SAFETY EVALUATION BY THE OFFICE NUCLEAR REACTOR REGULATION

TOPICAL REPORT NEDO-32465, SUPPLEMENT 1

“MIGRATION TO TRACG04/PANAC11 FROM TRACG02/PANAC10 FOR REACTOR
STABILITY DETECT AND SUPPRESS SOLUTIONS LICENSING BASIS METHODOLOGY
FOR RELOAD APPLICATIONS”

GE-HITACHI NUCLEAR ENERGY AMERICAS, LLC

Figure 4. Typical regional DIVOM slope (TRACG04 vs TRACG02)

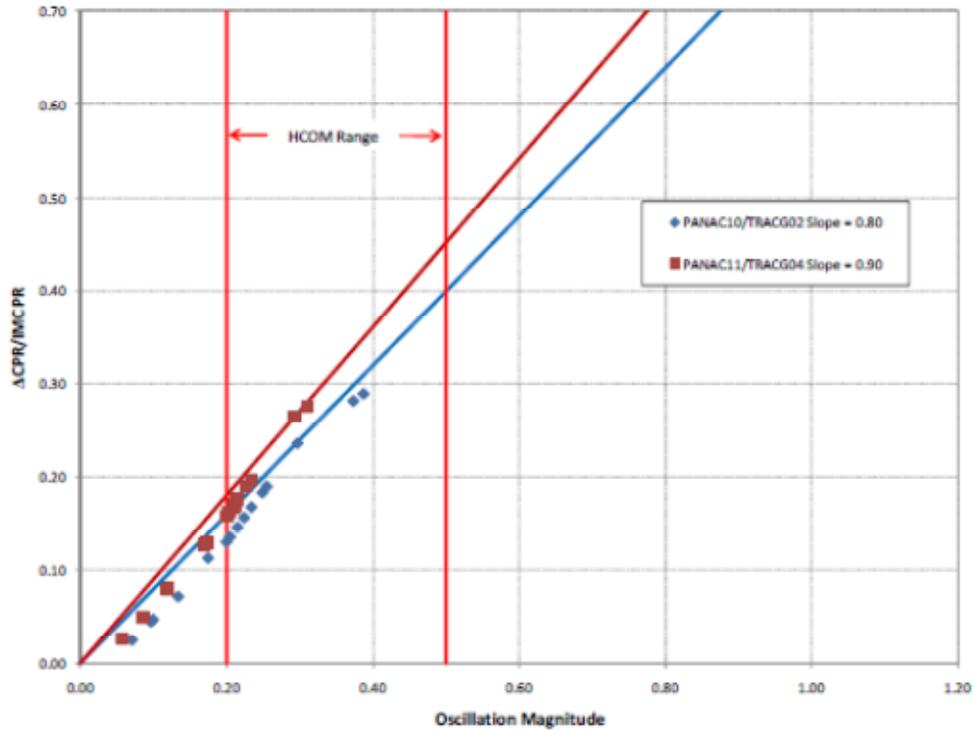
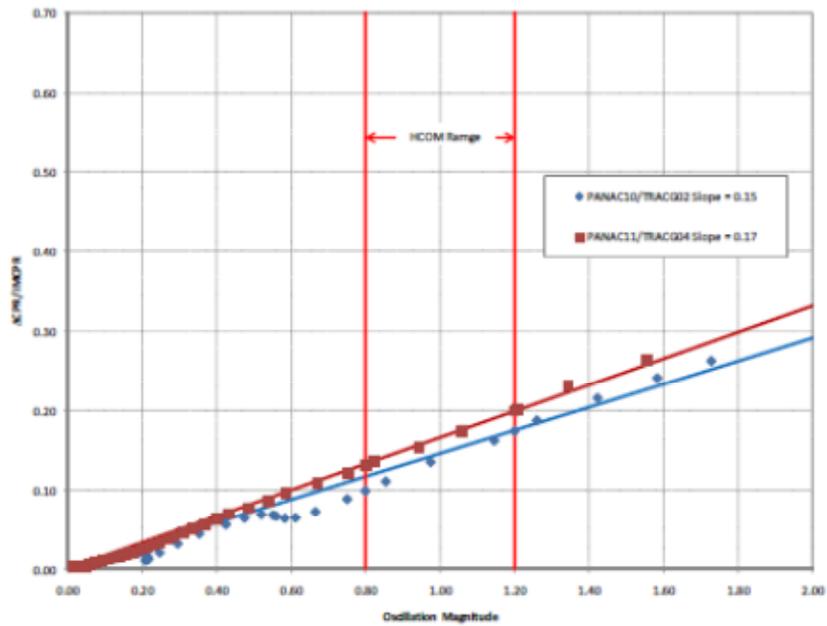
The main results of this benchmark indicate that the DIVOM slopes calculated by both methodologies are essentially identical, with the new TRACG04/P11 methodology being slightly more conservative (larger DIVOM slope) than TRACG02/P10. These benchmarks are reproduced here as **Figure 4** and 5. The NRC staff notes that in these figures the red line (TRACG04/P11) is slightly higher than the blue line (TRACG02/P10), which results in lower values of the scram setpoint and is more conservative.
